**Minet Infant and Junior School**  
**Cover Letter: MMA - Landscape Changes**  
 Application Ref. 2297/APP/2024/1212

*Material amendment to planning permission ref. 2297/APP/2021/2704, dated 16-09-2021, Extensions, remodelling and refurbishment of the existing Nursery, Infant and Junior Schools.*

**Schedule of Landscape Changes**

**01. Infant and Junior School Bin Store Relocation**

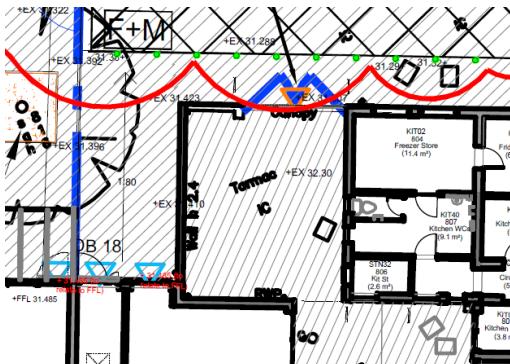
**REASON:** The bin store was relocated due to the existing bin store being in close proximity to the building. As such, this does not promote a good standard of hygiene and is not best practice with regards to fire safety compliance.

The bin store is now 10m away from all buildings onsite. The choice of the new location was driven by the route of the bin lorries collecting refuse. The bin lorries no longer need to access the school car park therefore improving pedestrian/pupil safety during collections.

The former grassed area is now permeable tarmac and used as a service yard. It is worth noting that this area does not form part of the playground or any play space and is out of bounds to pupils.

**02. Infant School Single Gate Leading to Bin Store / Service Yard**

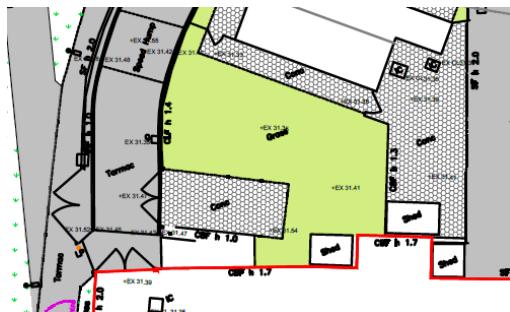
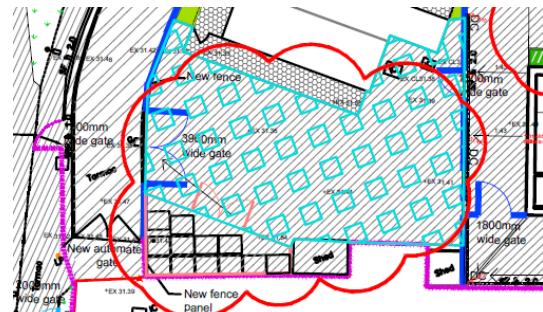
REASON: The addition of this single gate allows the Infant School to access the bin store and service yard from their side of the boundary.

Single gate adjacent caretakers house on right in blue.

**03. Junior School Single & Double Gates Leading to Bin Store / Service Yard**

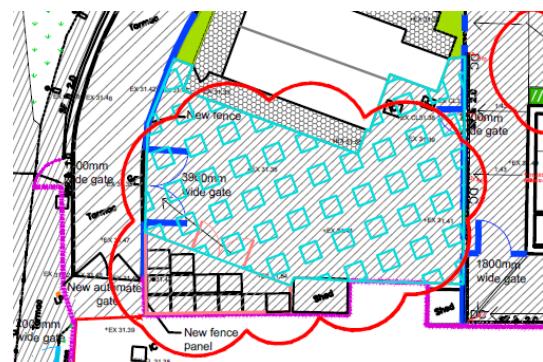
REASON: The addition of the single and double gates allows the Junior School to access the bin store and service yard from their side of the boundary.

Single and double gates adjacent caretakers house on left in purple and blue.

**06. Infant School Area Resurfaced with Tarmac**

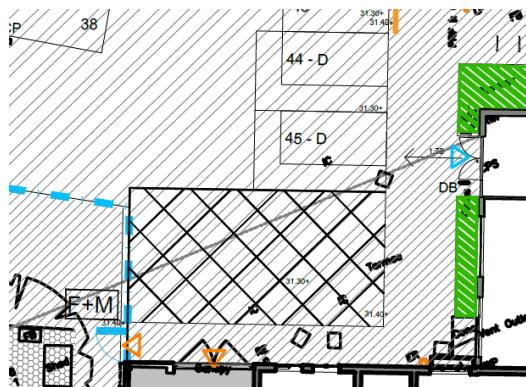
REASON: Originally this area was 'no-touch' however was resurfaced with new tarmac to match the existing condition. As such, there is no detrimental change to the visual appearance.

**08. Permeable Asphalt to the Infant and Junior School Car Park**

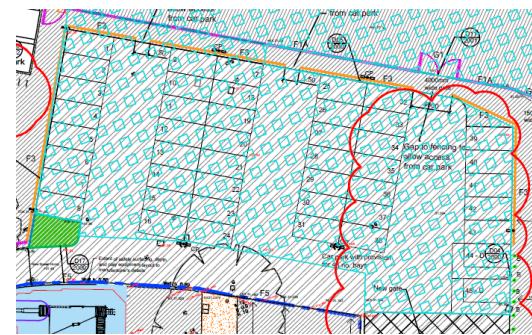
REASON: Permeable asphalt has been laid to the car park, however this does not result in any detrimental change to the visual appearance.

**09. Cycle Hoops Relocated from Junior School Playground**

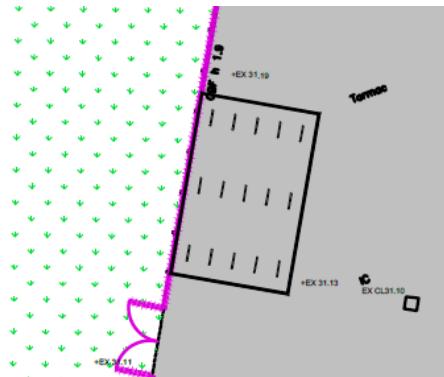
REASON: The location of the cycle hoops have been repositioned to the pedestrian area outside of the playground. This increases pupil safety in the playground and provides an increased area of play space.

**10. Additional Canopy Added to Existing Library Building to Junior School**

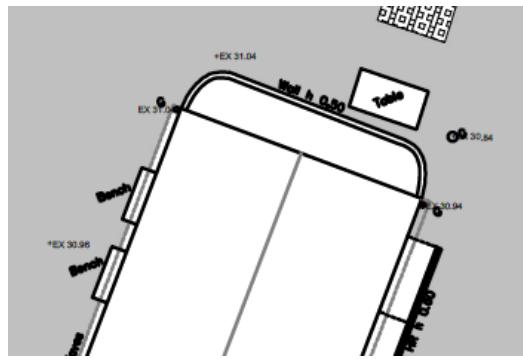
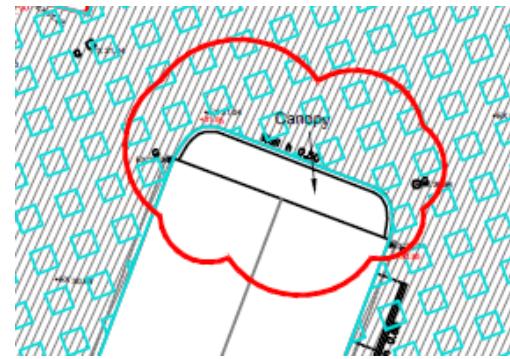
REASON: The Junior School requested for an additional canopy to be installed to the existing Library Building within the playground area. This provides pupils with an additional recreation area with a covered canopy and shading.

**11. Polytunnel to Junior School Relocated and Additional Gates**

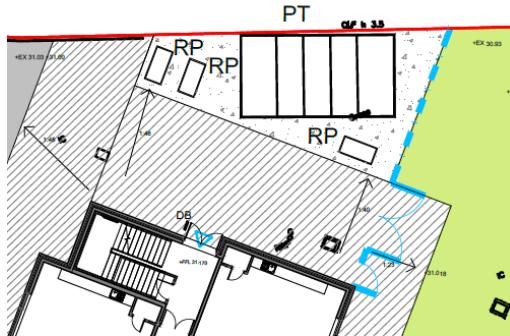
REASON: The polytunnel has been relocated to the playing field in order to provide the school with future flexibility with regards to the free space they now have as shown below to the triangulated area.

Additional gates have also been added to segregate this area from the playground and provide access/egress for regular maintenance to be carried out to the playing field.

**12. Junior School Existing Hexagonal Covered Play Area Relocated on Plan**

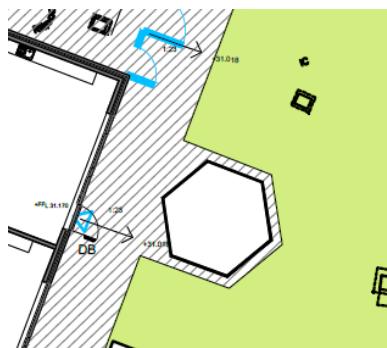
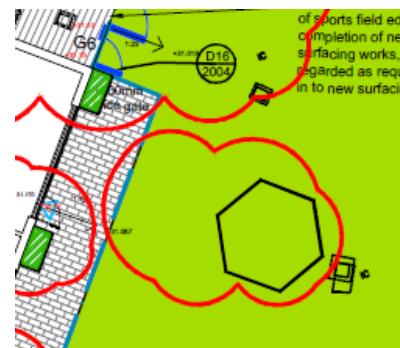
REASON: The location of the existing covered play area was shown incorrectly on the original plan and has therefore been updated for the Junior Schools records.

**13. Junior School Additional Fire Escape Added with Associated Paving and Removal of Pond**

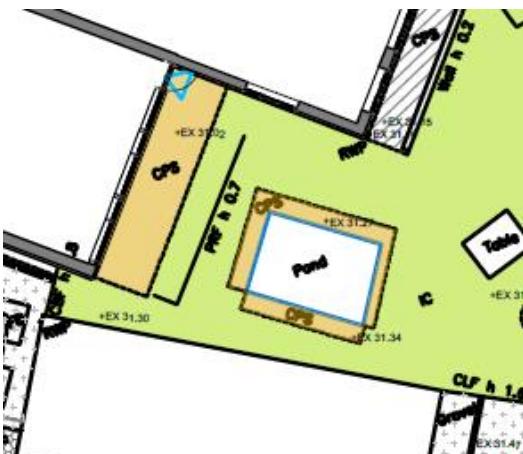
REASON: An additional fire escape door was added to the Junior School classroom including the associated paving. There was also a request from the end user to remove the pond which was unsuitable due to concerns around pupil safety.
